Submissions and Amendment Report

1 – 3 Skyline Place Seniors Housing
SSD – 69850712

Prepared for Platino Properties Pty Ltd

Submitted to DPHI

Figure 1 Proposed massing (Source: Smith & Tzannes)

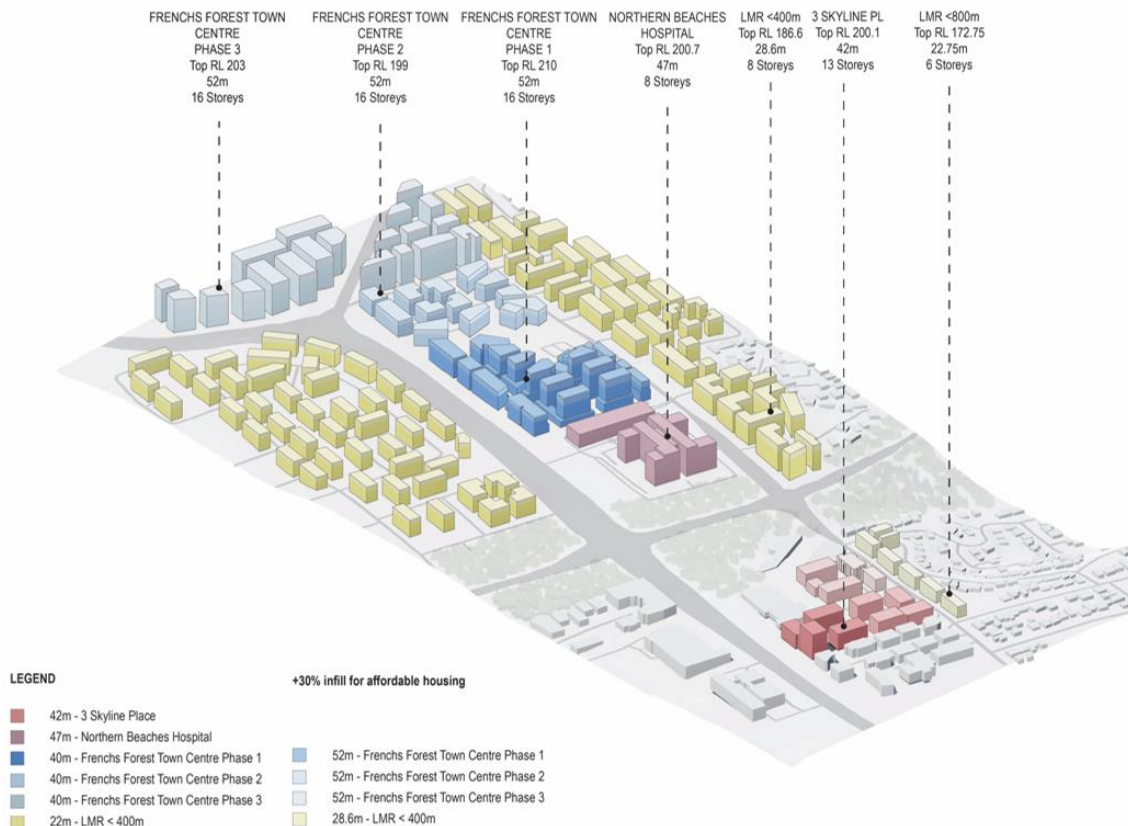
Height Context

- The revised tower form sits comfortably within both the existing and future context of the locality noting:
 - The existing Northern Beaches Hospital sits has a height of 47m.

- The Frenchs Forest Town Centre is subject to the following height limits:
 - 40m base height control, and
 - 52m (16 Storey) including the +30% infill for affordable housing bonuses afforded through the Housing SEPP controls.

- The figure below shows the proposed height in the future context of the area and demonstrates that the proposed height is compatible with the evolving built form character of the locality:

Figure 2 Proposed Massing, Proposed and 4-storey comparison (Source: Smith & Tzannes)

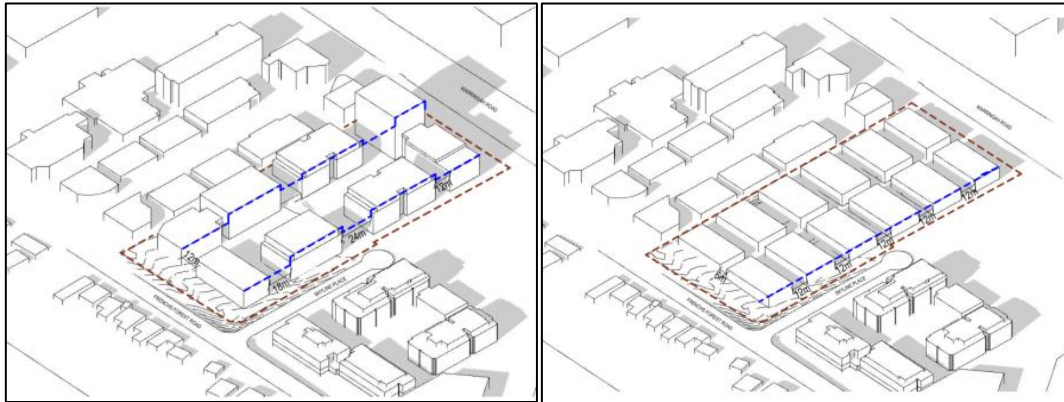
Alternate Massing and Comparative Analysis

- 4 storey envelopes across the site, which provide the minimum ADG compliant 12m building separation that result in greater overshadowing effects (when compared to the proposed scheme) and limited onsite amenity due to reduced opportunities for open space, deep soil and landscaping.

- 6 storey envelopes across the site, which provide the minimum ADG compliant 18m building separation. This option has the same shortcomings as the 4 storey option.

- 8 storey envelopes across the site. It is acknowledged this option provides an improved outcome when compared to the 4 and 6 storey alternatives. However, it still results in an inferior outcome when compared to the proposal due to the resultant overshadowing and constrained amenity outcome due to the development footprint.

- The preferred option and the 4 storey envelopes option are provided in the figure below. As demonstrated, the preferred option provides for the highest level of amenity as it consolidates landscaped open space, exceeds ADG building separation requirements across the site, and maintains a reduced height to Frenchs Forest Road and transition to lower density residential areas to the north.
